CITY OF EDMONDS
BUILDING DEPARTMENT
WORK Mechanical - Coolers + Condensers
ADDRESS 23028 100th Ave W
OWNER Bartell Drugs
APPROVED DATE: 4/24/12
BLDG. OFFICIAL
PERMIT NUMBER
PRD2012-0264

58 EDMONDS BARTELL DRUGS
23028 100TH AVE WEST
EDMONDS, WASHINGTON
FOR: BARTELL DRUGS

HVAC ROOF PLAN
SCALE: 1/8"=1'-0"

BARTELL WESTGATE

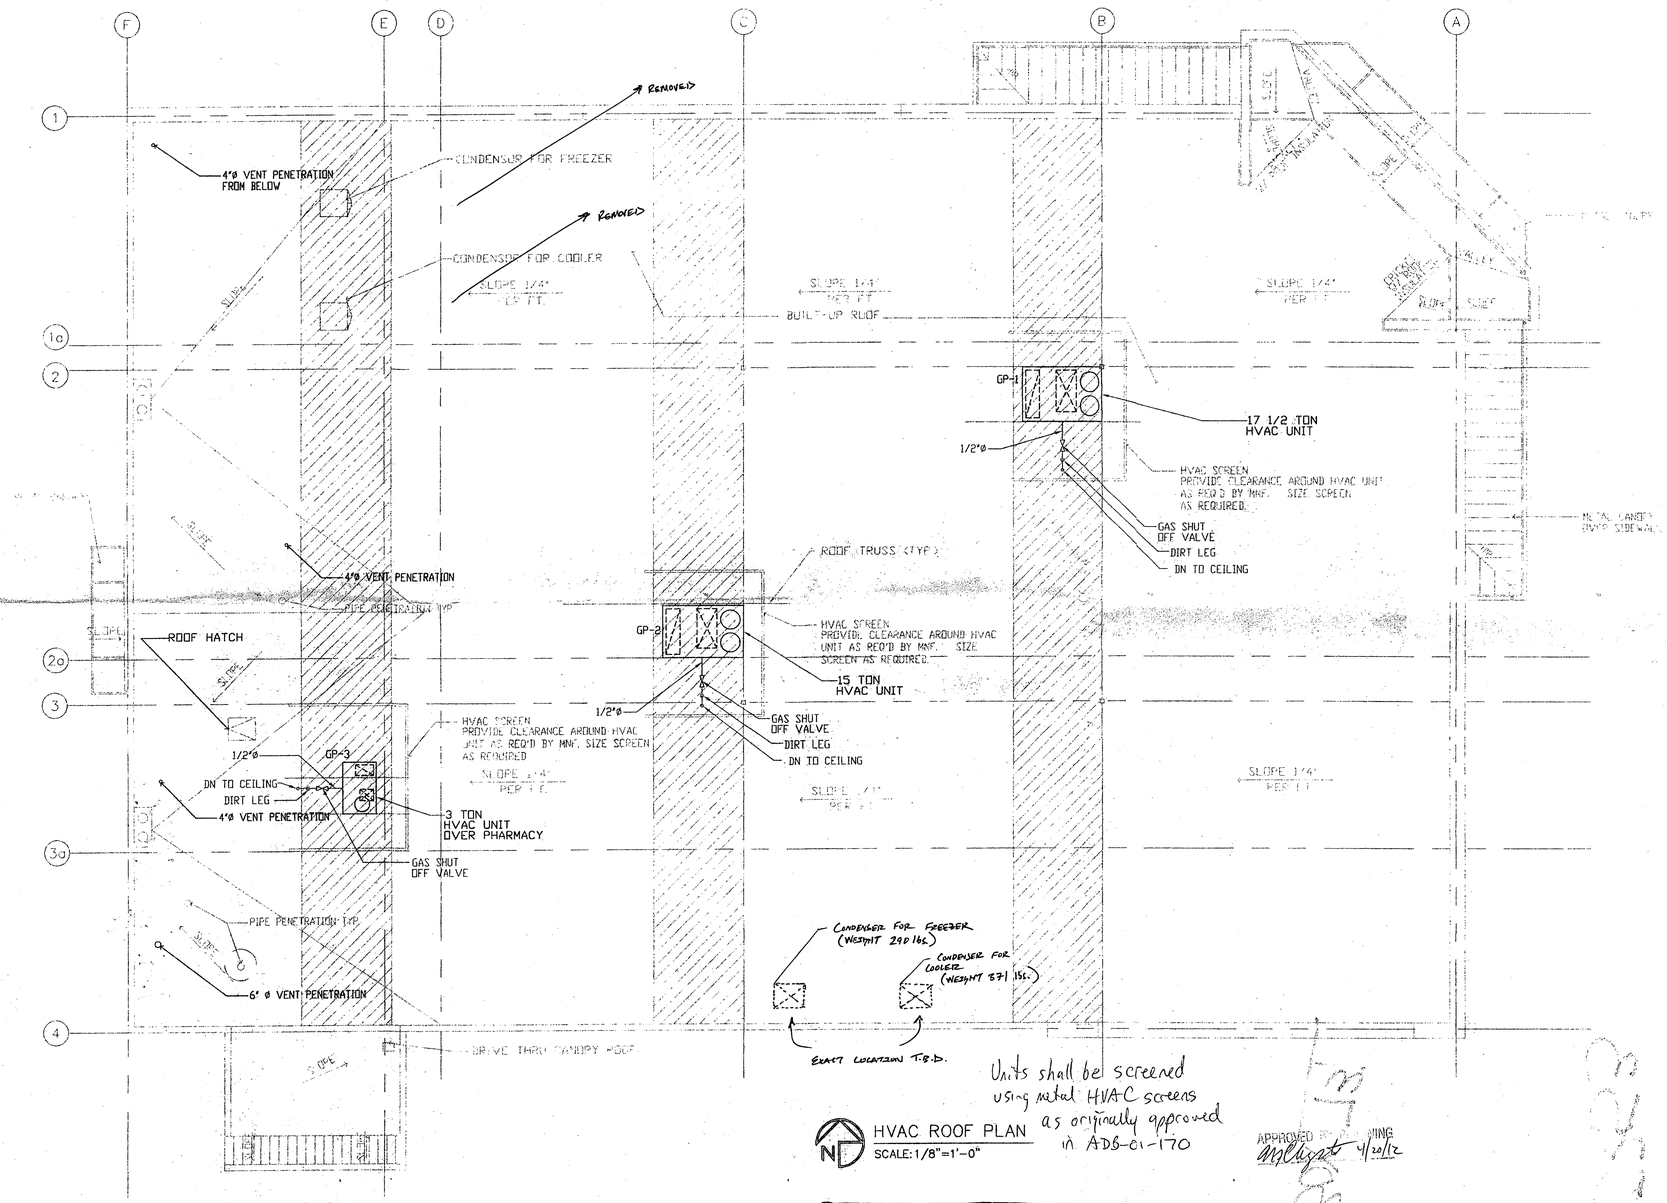
Units shall be screened using metal HVAC screens as originally approved in ADS-01-170

1013.5 Mechanical equipment. *Guards* shall be provided where appliances, equipment, fans, roof hatch openings or other components that require service are located within 10 feet (3048 mm) of a roof edge or open side of a walking surface and such edge or open side is located more than 30 inches (762 mm) above the floor, roof or grade below. The *guard* shall be constructed so as to prevent the passage of a sphere 21 inches (533 mm) in diameter. The *guard* shall extend not less than 30 inches (762 mm) beyond each end of such appliance, equipment, fan or component.

This plan to show Approx. locations of Condensor Roof top Units Only
